Memorandum

To: Mathew Wiley
CC: The Miller Hull Partnership LLP c/o April Ng
Site: Wiley Residence Remodel
Address: 6838 96th Ave SE, Mercer Island
Re: Assessment of Impacts to Tree 344 from Soldier Pile Wall Installation in Driveway
Date: January 10, 2024
Project Arborist: Connor McDermott,
ISA Certified Arborist PN- 8704A
ISA Qualified Tree Risk Assessor
Referenced Documents: Arborist Report (Tree Solutions Inc, 05/12/2022)
Grading Plan C200A (LPD Engineering, February 24, 2023)
Foundation Details (PCS Structural Solutions, February 24, 2023)
Garage Shoring and Wall Elevation Details S420 (PCS Structural Solutions, December 8, 2023)

Figure 1. Snip of the approved grading plan with Tree 344 indicated and the location of the retaining wall shown (Grading Plan C200A, LPD Engineering, 02/24/2023).

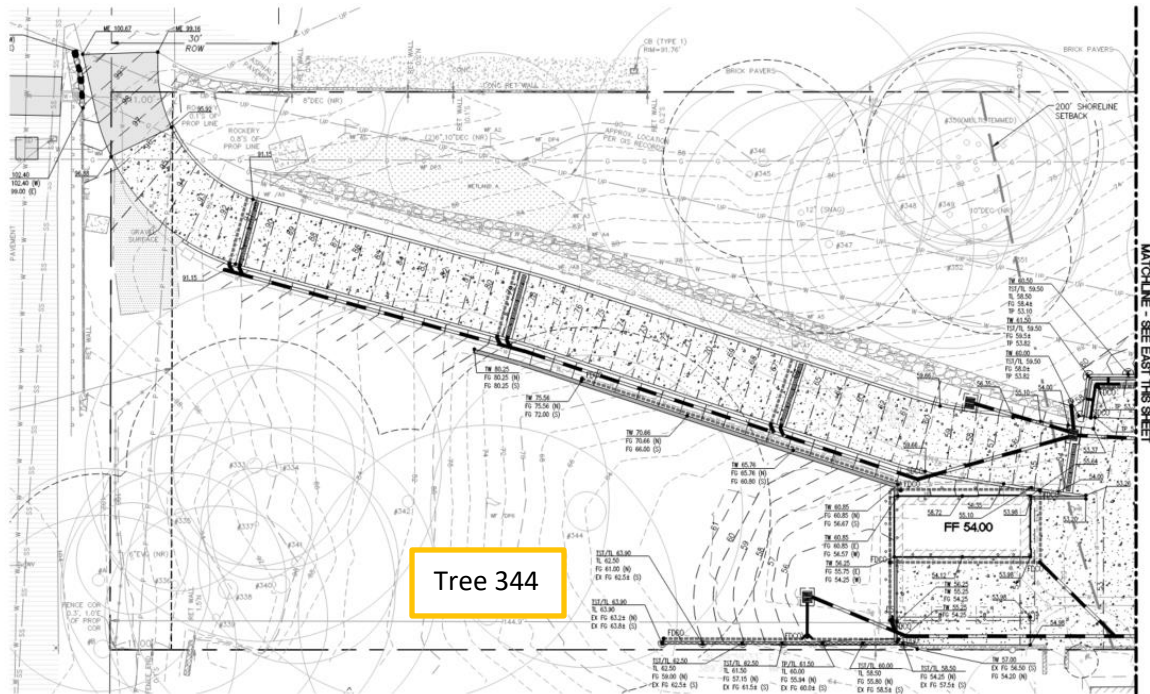
Tree 344 is an exceptional western redcedar that measured 49.7-inch diameter at standard height and had a RLOD of 33 feet. The approved construction plans called for the construction of a concrete retaining wall south of the existing driveway and north of tree 344 (Figure 1). The foundation of the concrete retaining wall had a four foot wide footing that required encroachment into the minimum limits of disturbance (MLOD) of tree 344 and up to 15 feet from the base of the tree (Figure 2).

I believe the long term health of tree 344 will not be impacted if excavation within undisturbed soils is limited to the placement of beams for the piles. I recommend the location of the piles are first ground

with a grinding or reciprocating attachment head on the auger for the initial four feet to cleanly cut any roots in the vicinity. No machinery or materials should be stored on top of undisturbed soils within the RLOD of the tree. I recommend the installation of the piles within the RLOD of tree 344 are monitored by the project arborist to guide installation and determine rooting impacts.
